## Bulletin

**Application:** Chrysler 41TE (A604) 1989-Up; 42LE (A606) 1993-Up; 42RLE 2003-Up  
**Subject:** Revised Low/Reverse Clutch Retainer Gasket

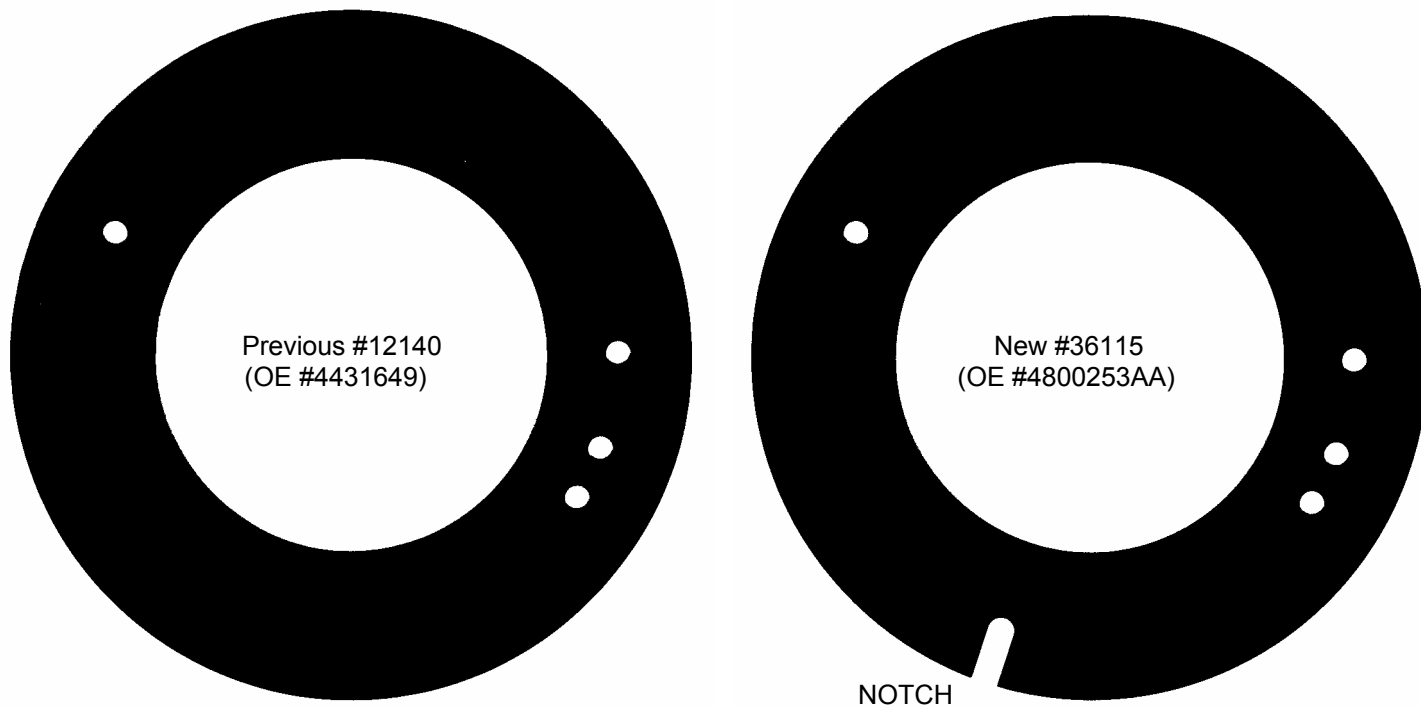
The 42RLE, new in model year 2003, uses a new low/reverse clutch retainer gasket. The new gasket looks similar to the previous A604 part, but with the slight revision of an added notch in the new gasket (see illustration).

Chrysler is superceding the previous gasket #4431649 with the new part #4800253AA as stock is exhausted. All TransTec overhaul kits for the 42RLE have been built with the new gasket (TransTec #36115), and we are also switching to it in all A604/A606 kits as current gasket stock is depleted.
